CREST AUDIO INC.

IPR 3000 DSP Amplifier Section

CREST AUDIO INC.			
TITLE: IPR 3000 DSP Power Supply			
DRAWN:	DATE:	CODE:	REV:
CHECKED:	DATE:	D	DRAWING NO.:
QUALITY CONTROL:	DATE:		
RELEASED:	DATE:

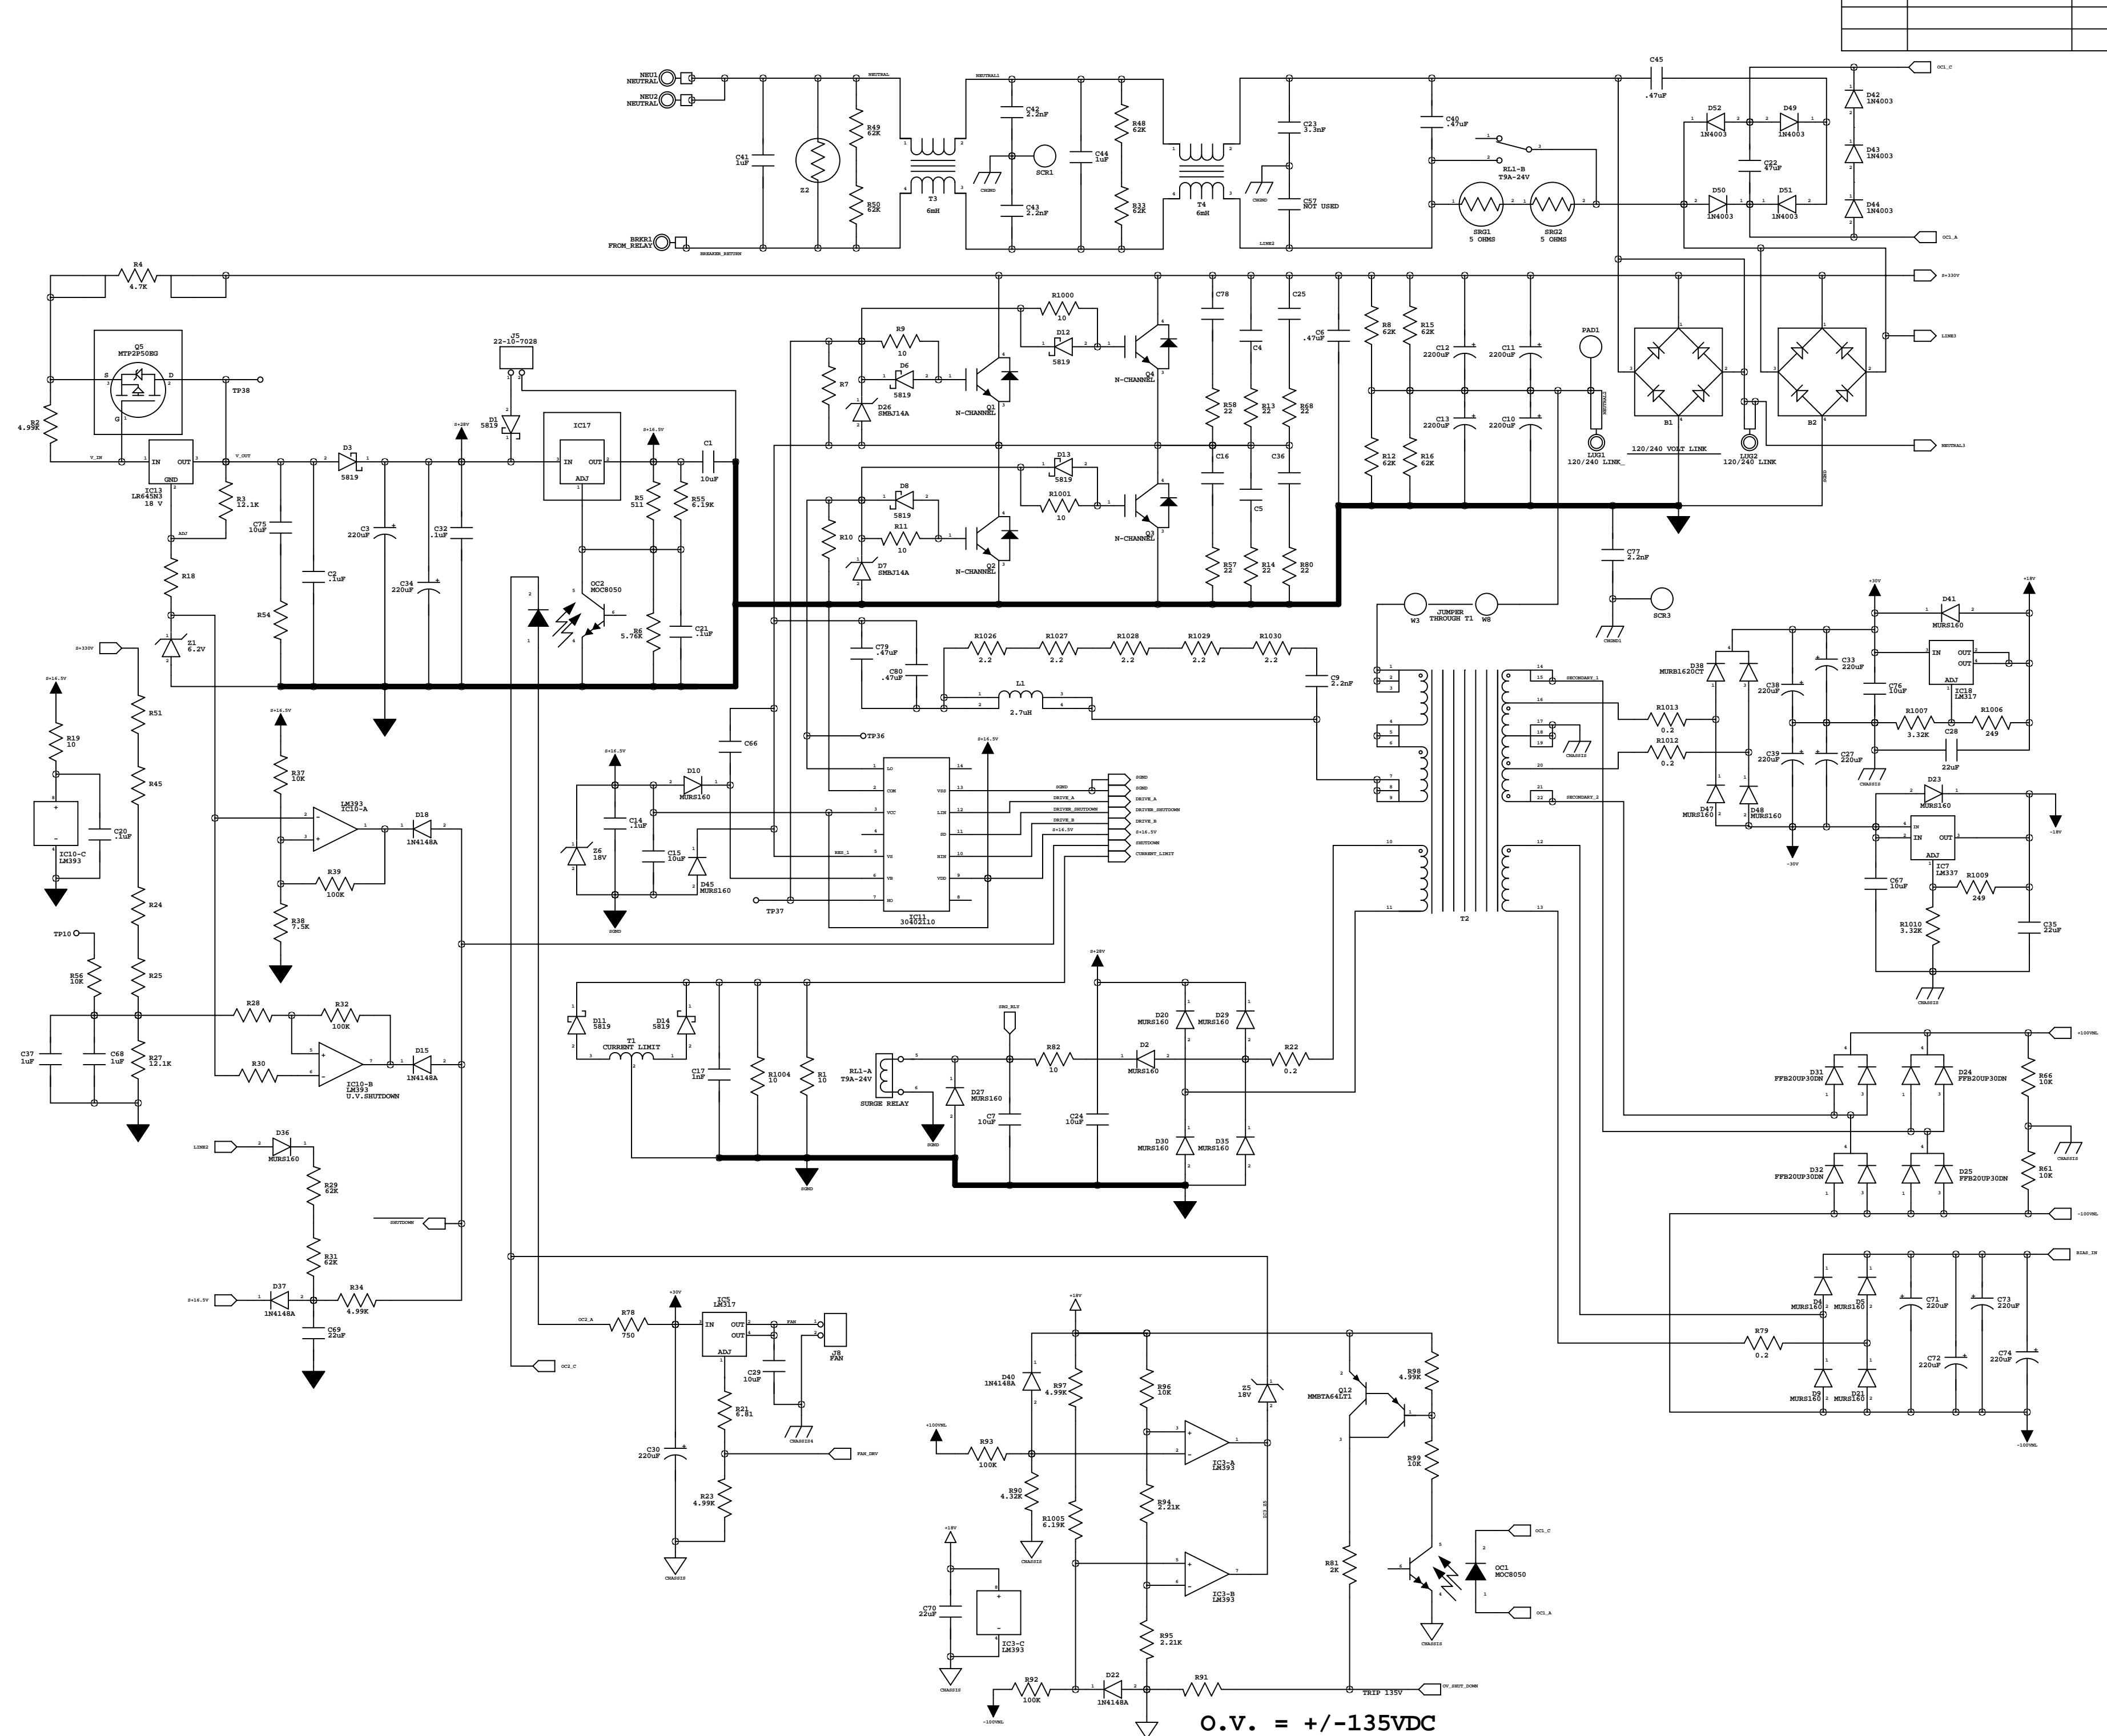
ECN22735

06/07/11 Deleted R2000 30200174

ECN22777

07/22/11 Changed D101, D102, D201, D202 from 30418272 to 30419246

07/22/11 Changed Q105, Q107, Q205, Q207 from 30418774 to 30419245

07/22/11 Changed Q104, Q106, Q204, Q206 from 30418773 to 30419244

ECN22842

09/02/11 Changed D108, D109, D110, D111, D208, D209, D210 & D211 from 30418328 1N4148 to 30419248 1N5819HW

ECN22908

11/01/11 Changed C61 from 30300130 1uF to 30300069 .22uF

11/01/11 Changed R88 from 30200443 2.2 Meg to 30200338 5.62Meg

11/01/11 Changed R1014, R1015, R1016, & R1017 from 30200238 22 ohm to 30200388 150 ohm

11/01/11 Changed R74 from 30200174 10K to 30200194 100K

Do not install R2000
 Do not install C23 30330182
 Do not install R26 & R260 30200443
 Do not install C57 30320322
 Do not install C114A & C214A 30330148
 Do not install J100 & J200 33717254
